| This ASB revises ASB-912-061UL dated 26 May 2012

ALERT SERVICE BULLETIN

Replacement of the pressure side fuel hose at fuel pump part no. 893114 for ROTAX® Engine Type 912 (Series)

ATA System: 73-00-00 Fuel system

Fig. 1
Fuel pump

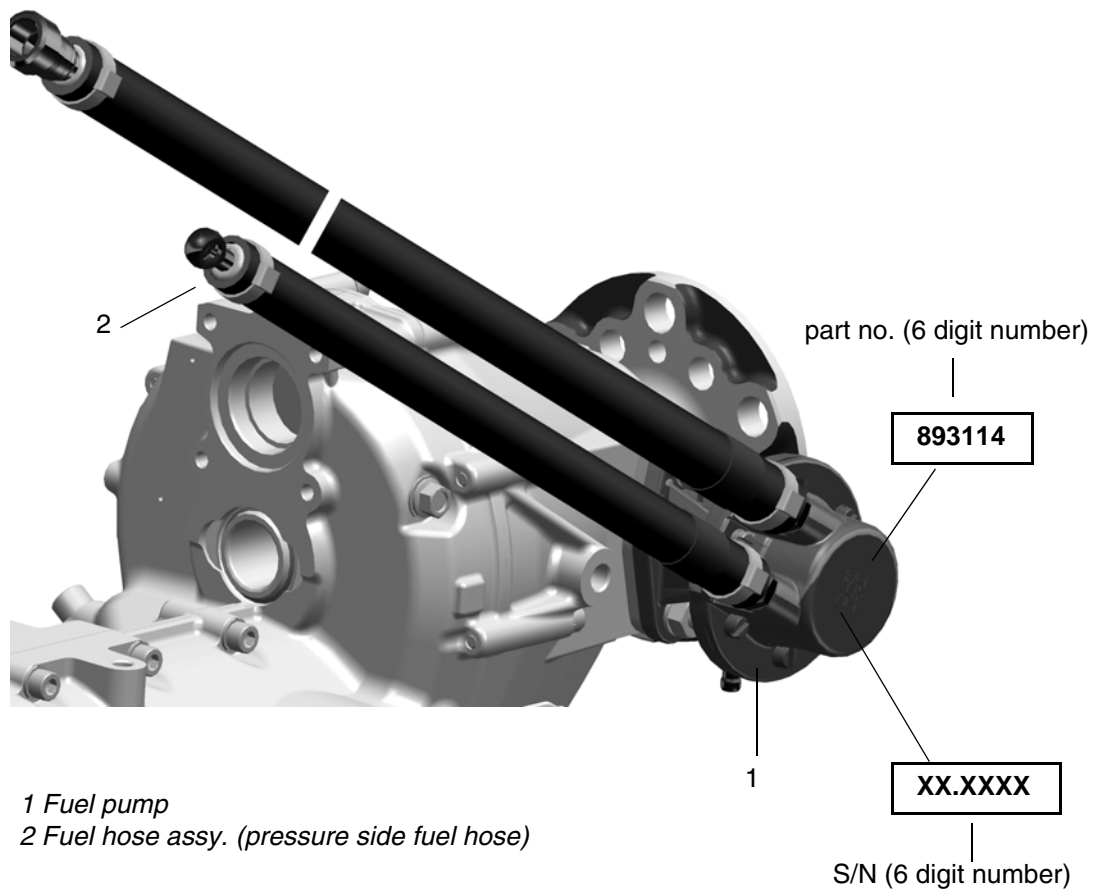
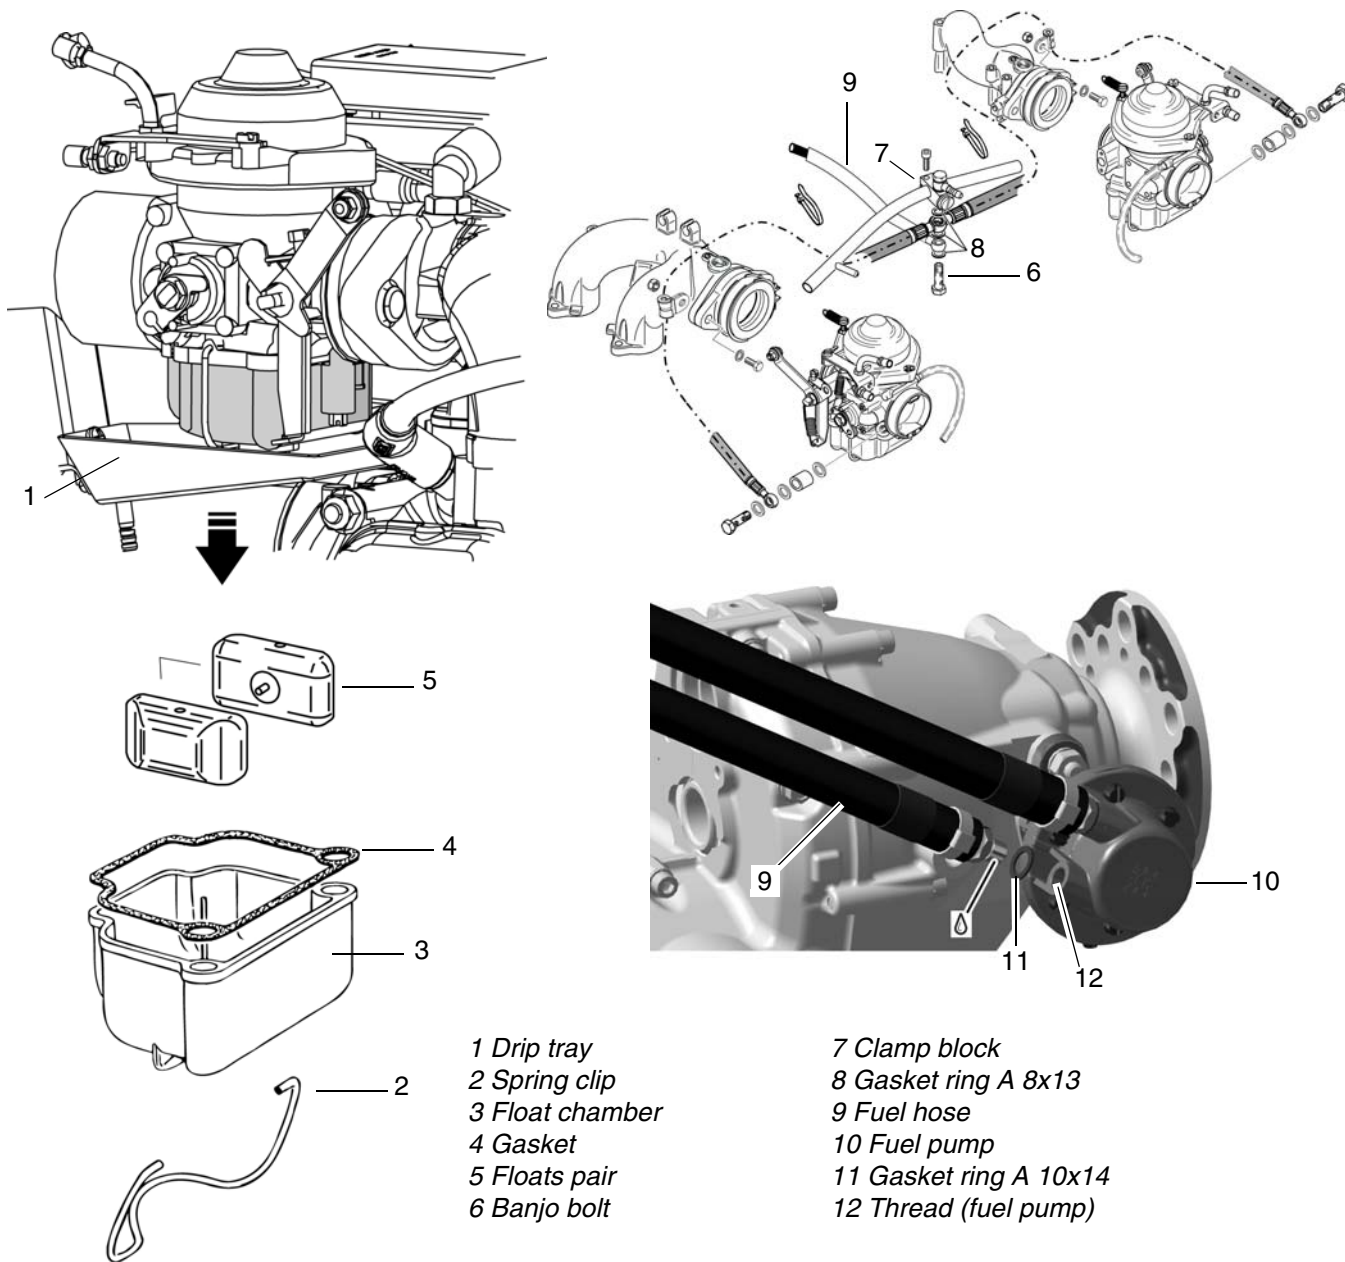
if they are equipped with the genuine ROTAX® fuel pump part no. 893114.
See [Fig. 1](#)
